RE: **Palen Solar Power Project, Docket No. 09-AFC-7**
Responses to January 14, 2010 CEC Workshop Queries (Groundwater)
Technical Areas: Soil & Water Resources

**Responses to CEC Workshop,
January 14, 2010
Soil and Water Resources
(Groundwater)**

**Palen Solar Power Project
Docket No. 09-AFC-7**

Groundwater Data Responses to January 14, 2010 CEC Workshop Queries – Palen Solar Power Project

Palen Solar Power Project
Figure DR-S&W-194-1 (Rev. 1)
Average Annual Precipitation
1931-1961 (Hely & Peck, (1964))
Chuckwalla Valley
Groundwater Basin

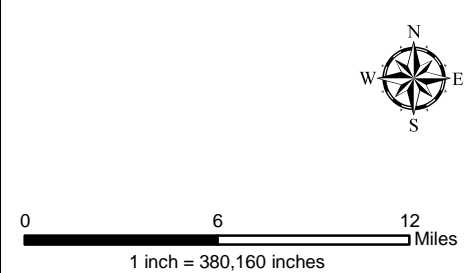
Update the runoff recharge estimates (DR-S&W-194) to reflect 2, 5, and 10% of total calculated runoff value. Use the Basin inflow/outflow example from Genesis (WorleyParsons 2009b).

A revision to the water balance provided in the January 6, 2010 response to Data Request (DR)S&W-194 for the Chuckwalla Valley Groundwater Basin (Basin) was made to reflect a change in the estimate of infiltration from precipitation after Hely and Peck (1964) and to reflect the results of fieldwork in the northern portion of Palen Dry Lake completed by WorleyParsons (2009b). No other changes were made to the water balance estimates included in the January 6 response to DR-S&W-194.

In revising the infiltration estimate, the first step was to overlay the average annual isoheytal contours shown on Figure 6 from Hely and Peck (1964) onto the topography of the Chuckwalla Valley Groundwater Basin (Basin) (Figure DR-S&W-194-1 [rev1]). The second step was to multiply the

average annual precipitation within each contour times the area of the contour to derive an estimate of total precipitation in acre-feet for the Basin. Lastly, the total within each contour is multiplied by percentages of 3%, 5% and 10% representing an estimate of infiltration from precipitation within the contour and summing the individual areas to a total annual infiltration volume (acre-feet) for the Basin. Table DR S&W-194-1 (rev1) presents the estimate of total annual infiltration for the Chuckwalla Valley Groundwater Basin for these estimates of infiltration which vary from about 8,600 acre-feet (3%) to 28,600 acre-feet (10%). The infiltration estimate of 3% of precipitation compares favorably to the value estimated by WorleyParsons (2009a, Table DR-151-2) of 9,440 acre-feet.

Figure DR-S&W-207-3
Transmissivity in the
Chuckwalla Valley

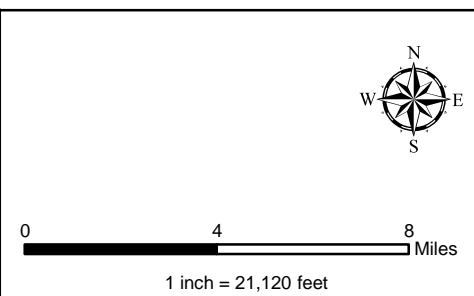
Provide evidence that Project water demand can be met without impact to nearby wells or creating Basin overdraft.

The groundwater model that was provided in the data response dated January 6, 2010, was revised to reflect an updated interpretation of the distribution of transmissivity within the Basin. Bedinger et al 1989, in their mapping of the Chuckwalla Valley show a zone of fine-grained sediment below Palen Dry Lake extending from the surface to the Mesozoic basement rock (Cross Section E-E'). Simoni (1981) described two test well borings (Palen Lake No.1 and No.2) dug south-southeast of the lake, just north of the PSPP site as being predominantly fine-grained to depths of 425 and 505 feet below the ground surface, respectively. The results of the borings by Simoni (1981) generally reflect similar fine-grained conditions that were encountered in the drilling of the observation wells dug as part of the PSPP AFC pumping test program. Additionally, the low-well yield experienced during the pumping test on former agricultural well 5S/17E-33N01 is suggestive of lower transmissivity conditions and fine-grain materials, although it is probable that the well condition and age (installed in 1958) contributed to well performance.

These data along with published data from across the Basin were used to refine and remap the transmissivity zones for the groundwater model (see Figure DR-S&W-207-3). The lower transmissivity value from the Project's recent aquifer test (1,000 ft²/d) was applied to Zone 1, which

includes the PSPP site and Palen Dry Lake, as well as the area around Ford Dry Lake. Apart from this area, the lower transmissivity value previously determined by USGS (6,300 ft²/d) (Leake et al. 2007) was applied to Zone 2, which includes areas east and west of the central low-transmissivity zone. This value appears to be a reasonable approximation of transmissivity data reported in these areas in the western and eastern portions of the Chuckwalla Valley. In addition to the published transmissivity data shown on Figure DR-S&W-207-3, available pumping data and specific capacity data were used to map the transmissivity across the Valley (see Figure DR-S&W-207-4). Higher pumping rates reported in the area of CocoPah Farms were used to demark higher transmissivity zones due west of the PSPP site. It is important to emphasize that the numerical modeling is a 2-D simulation and as such the transmissivity values are uniformly applied through the model domain and assumed constant through the vertical extent of saturated sediments. This represents a conservative approach to the analysis of water supply and impacts from the Project, as it presumes vertical uniformity of aquifer characteristics that are not documented in the hydrostratigraphy for the Basin. The Basin shows significant heterogeneity and possibly higher transmissive sediments at depth below the Project and in the central portion of the Basin.
